Review and Proposed Amendment of the Technical Rules for Western Power's South West Interconnected Network

August 2011

Economic Regulation Authority

Figure 2.2-1 - Highest acceptable level and duration of AC temporary overvoltage

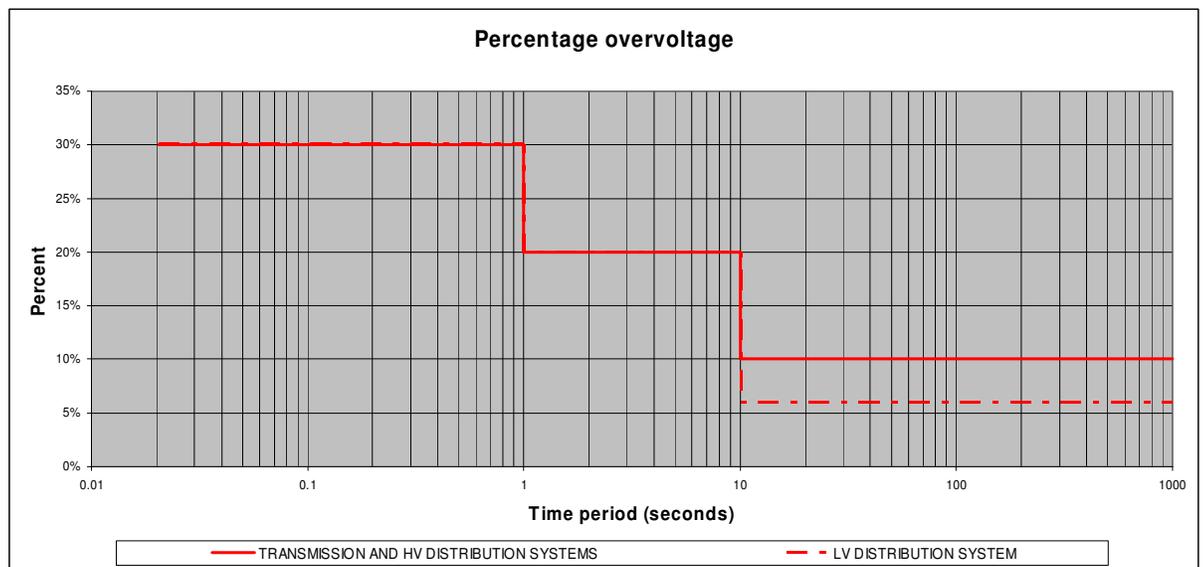
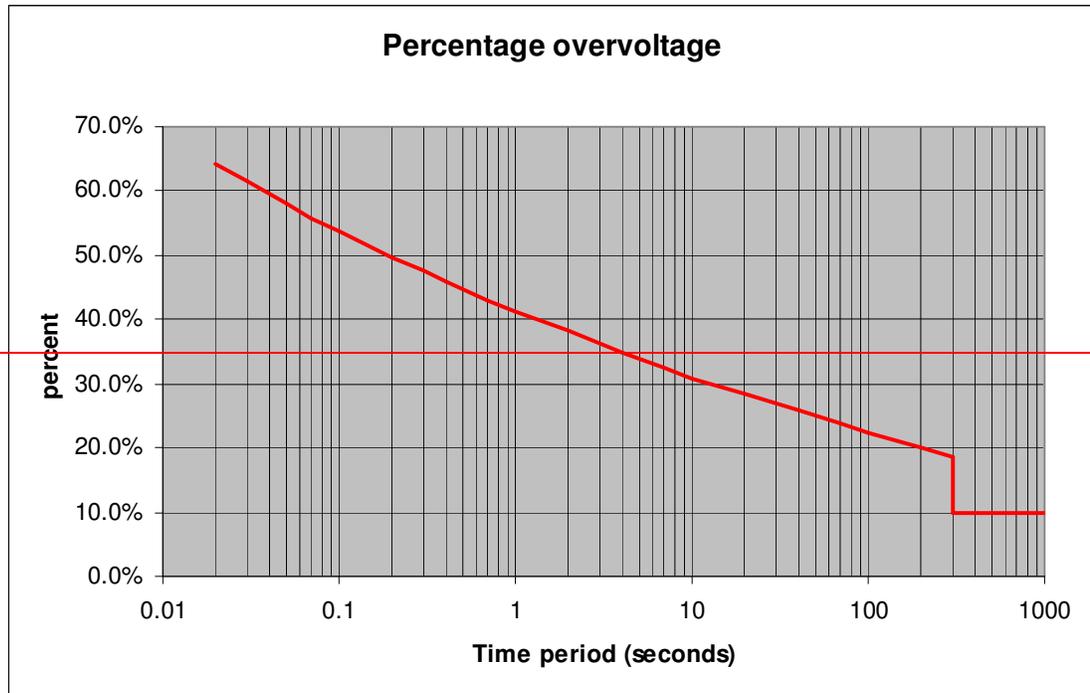
29. During the final SGWG meeting an issue was raised regarding the maximum allowed connection point over-voltage specified in Figure 2.2 of the current Technical Rules. It was argued that this allowed higher over-voltages than permitted by the National Electricity Rules (NER) that apply to the NEM. This potentially posed a barrier to entry for large inverter coupled renewable energy generators, which were intolerant of high network voltages. It was argued that these generators would not be able to connect to the South West Interconnected Network (SWIN), even though there was no barrier to the same generator connecting to NEM networks.

30. Western Power advised that Figure 2.2 is based on an old study and has not been updated. It was suggested that a review of Figure 2.2 could see the permitted maximum network over-voltage reduce. In the interim, it was suggested that proponents could contact Western Power and request an assessment based on the site-specific requirements.

31. Western Power initially indicated that a review of Figure 2.2 could take several months. The Committee recommended that the revised figure be included in the revised Technical Rules.

32. Western Power has since resubmitted a revised over-voltage envelope that is more favourable to users than the envelope in the current Technical Rules, but not as favourable as the envelope in Figure S5.1a.1 of the NER. The revised over-voltage envelope has been included as Figure 2.1 in the revised Technical Rules. Western Power has advised the Authority that it is not currently able to meet the envelope in the NER at some grid locations due to the type of protection currently installed. This primarily affects locations on the fringes of the network. The Authority accepts that Western Power's revised envelope is appropriate.

2.2.10	Over-voltage envelope	The clause has been modified in accordance with paragraphs 29-33 of this Review Report.
2.3.7.1	Network modelling assumptions.	The clause has been modified in accordance with paragraphs 72-76 of this Review Report.

As a consequence of a *credible contingency event*, the *power frequency voltage* at all locations in the *power system* must remain within the over-voltage envelope shown in Figure 2.21.

Figure 3.4 – Off nominal frequency operation capability requirement for generating units

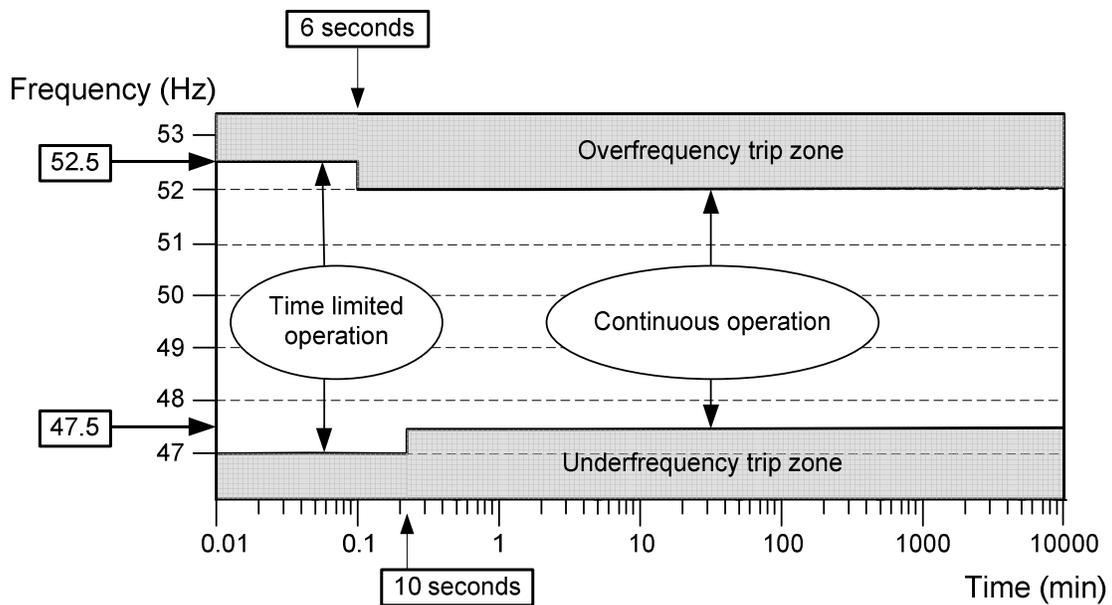
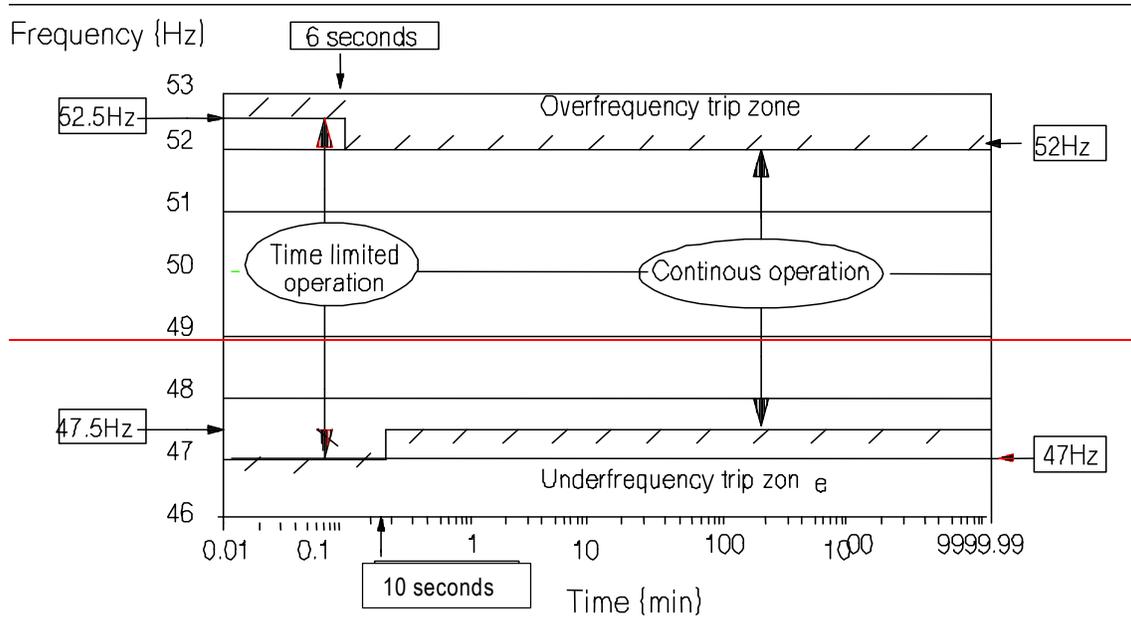
No	Sec.	Section Title	Proponent/s	Issue	Change suggested by WP	Discussion at Meeting	Outcome
20	Clause 3.3.3.3(b)	Frequency Capability	Western Power	<p>Add an explanatory box that Figure 3.4 includes a safety margin from Table 2.1 (frequency operating standards set by the System Management on the basis of the generation reserves set by the Independent Market Operator (IMO)).</p> <p>In other words, Western Power, as the Network Service Provider, has limited influence over the frequency operating standards and system operation which is governed by the Market Rules.</p> <p>Consequently, Western Power, as the Network Service Provider, wishes to:</p> <p>(1) discharge its responsibility for decisions that may impair operation of the SWIS as is defined in Table 2.1, and</p> <p>(2) elevate the role of the System Management in decisions that potentially have major impact on their work and operation of the Wholesale Electricity Market.</p>	<p>Clause 3.3.3.3(b): Add an explanatory note to Figure 3.4: "Note: <u>The requirements of Figure 3.4 provide a safety margin relative to the frequency operating standards of Table 2.1, within which a Generator may apply for an exemption from compliance from these Rules.</u>", Together with two new subclauses: "(1) <u>The Generator must demonstrate that the safety margin, relative to the frequency operating standards of Table 2.1, is achieved to satisfaction of the System Management.</u> <u>(1)(A) The proposed arrangement, if any, must not adversely affect System Management's ability to meet its obligations under the Market Rules and these Rules.</u> <u>(1)(B) Pursuant to clause 3.3.3.3(b)(1)(A), the Generator has the sole responsibility for the installation, maintenance and correct operation of any such an arrangement.</u></p>	<p>assume that a zero output would suffice, which would contravene the purpose of the clause).</p> <p>Neil Liddelow and Karthi Mahalingham raised issues with the drafting, particularly on the issue of liability. The use of "sole responsibility" was seen to be removing liability from System Management and Western Power. Karthi Mahalingham noted this brings contractual issues into a technical document.</p> <p>Zoran Bozic clarified that that is not the intent of the changes; they are intended to illustrate the process for getting approval from System Management to operate a particular equipment arrangement.</p> <p>Andy Wearmouth questioned whether one non-complying unit in a power station rules out the entire power station. Zoran Bozic stated that is not the case, power station refers to auxiliary</p>	<p>WP to redraft the section to not imply the Generator is responsible for any errors or omission by System Management or the NSP.</p> <p>The auxiliary equipment change was agreed to by all.</p>

1. The requirements of Figure 3.4 provide a safety margin relative to the frequency operating standards of Table 2.1, within which a Generator may apply for an exemption from compliance from these Rules.
2. These requirements must be met for all operating conditions, including ambient temperature. Unless operating restrictions have been agreed in accordance with clause 3.1(b) the Network Service Provider may assume the site specific maximum ambient temperature indicated in clause 3.3.3.1(a) when assessing compliance with the requirements of this clause.

Figure 3.67 Schematic diagram for the connection of an inverter *energy* system

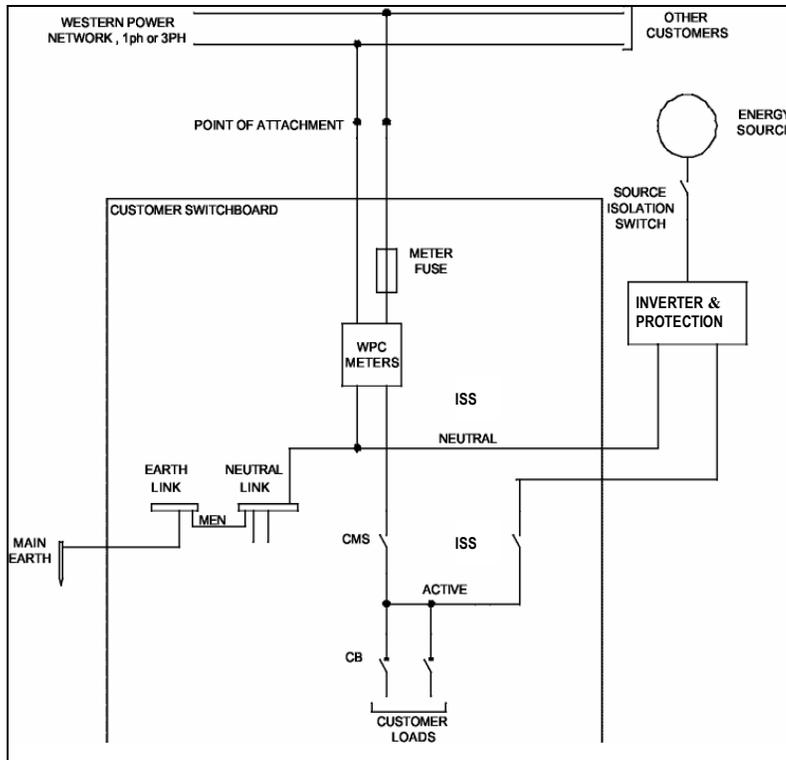
No	Sec.	Section Title	Proponent/s	Issue	Change suggested by WP	Discussion at Meeting	Outcome
	Table 3.8 Clause 3.7.9, Table 3.9				Table 3.5 Table 3.7; Table 3.8 to be new Table 3.6 Table 3.6 Table 3.8; Table 3.9 to be new Table 3.7 Table 3.7 Table 3.9;		
68	Clause 3.3.3.3c(2) Figure 3.5a Clause 3.3.3.3(e) Figure 3.5b Clause 3.7.6.2 Figure 3.6	Numbering of figures	Western Power	The notation of Figures 3.5a and 3.5b is inconsistent with sequential numbering used in the remainder of the Rules.	Renumber Figures 3.5a, 3.5b and 3.6 as new respective Figures 3.5 to 3.7 and change the cross-references in the body of the text accordingly, as follows. Figure 3.5a to be new Figure 3.5, i.e. Figure 3.5 Figure 3.5a; Table 3.5b to be new Table 3.6, i.e. Figure 3.6 Figure 3.5b; Table 3.6 to be new Table 3.7 Figure 3.7 Figure 3.6;		Agreed to by all.
69	Clause 4.2.2	Commissioning	Western Power	The design safety and compliance with the Rules need to be certified before energizing the installation.	Add new sub-clause 4.2.2(b)(1) to that effect as follows: <u>(1) The Network Service Provider must not approve energization of the User's equipment before the User's design has been certified by a Chartered Professional Engineer with National Professional Engineer's Register Standing qualified in the relevant discipline for compliance with these Rules and safety to satisfaction of the Network Service Provider.</u>	Neil Liddelow noted that requiring certification prior to energisation was too late in the process, and it would be more useful to have it earlier. Other members felt that by having this requirement in the Rules, it would alert users to the requirement for doing so and they could schedule it when it suited them best..	Agreed to by all
